BANKSTOWN CITY COUNCIL

STORMWATER SYSTEM REPORT 116 - 124 Restwell Street, BANKSTOWN NSW 2200

Date: 04-Mar-2016
Ref: WP-SIA/220/2016
Development type: **Residential Flat Building**

**100 Year ARI Flood Extent and Flood Contour Levels
(mAHD) from Salt Pan Creek Catchment
for 116-124 Restwell Street, Bankstown**

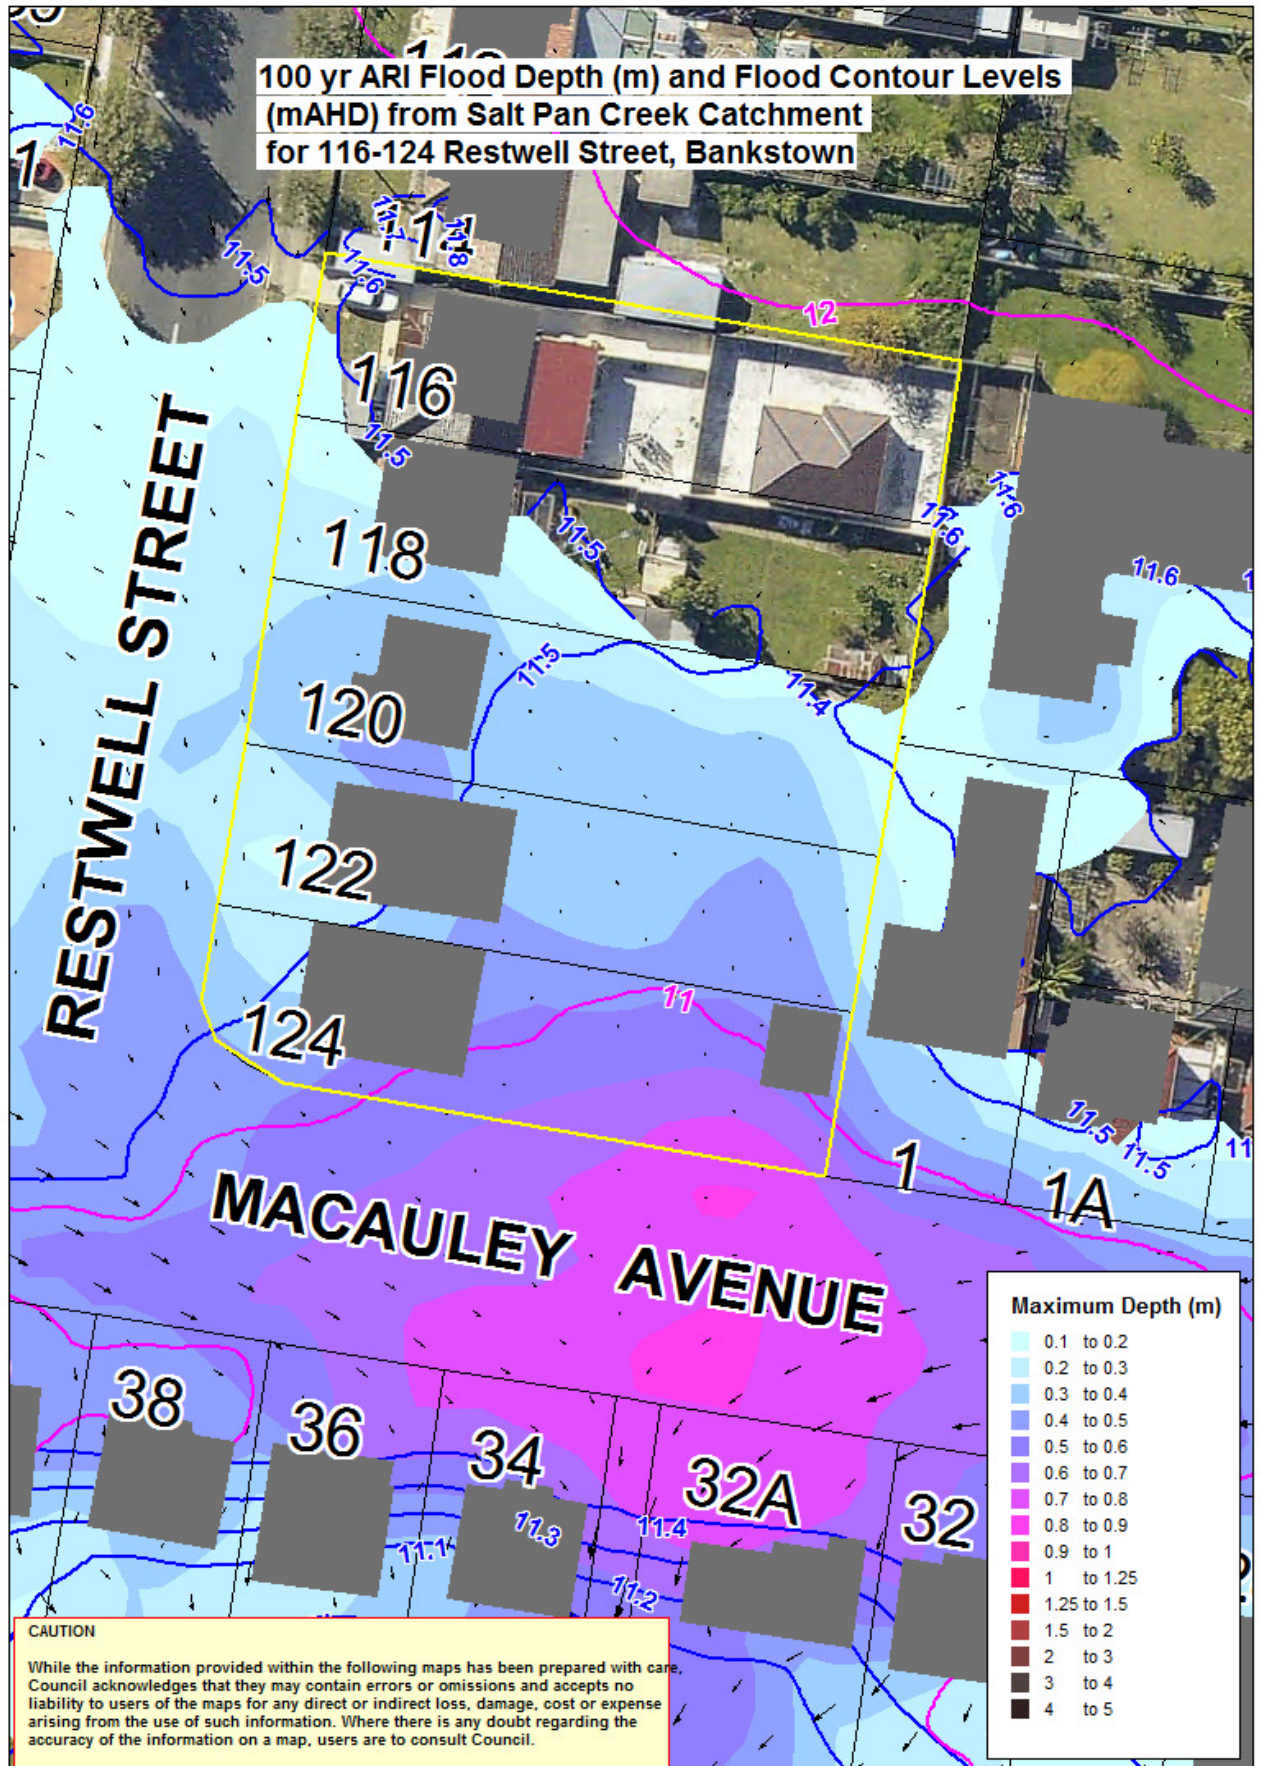
The site will be subject to stormwater inundation from this overland flowpath during large storm events. Refer to the attached "**100 Year ARI Flood Extent Maps from Salt Pan Creek Catchment Study**" showing the flood contours to m AHD**. Provision should be made on site, and at boundary fences, for this stormwater runoff to pass unobstructed over the site. Stormwater flowing naturally onto the site must not be impeded or diverted.

The designed 100 year ARI* flood level at the site is RL 11.5 m AHD.**

Habitable floor levels are to be [generally] at least 500mm above the 100 year ARI* flood level at the site.
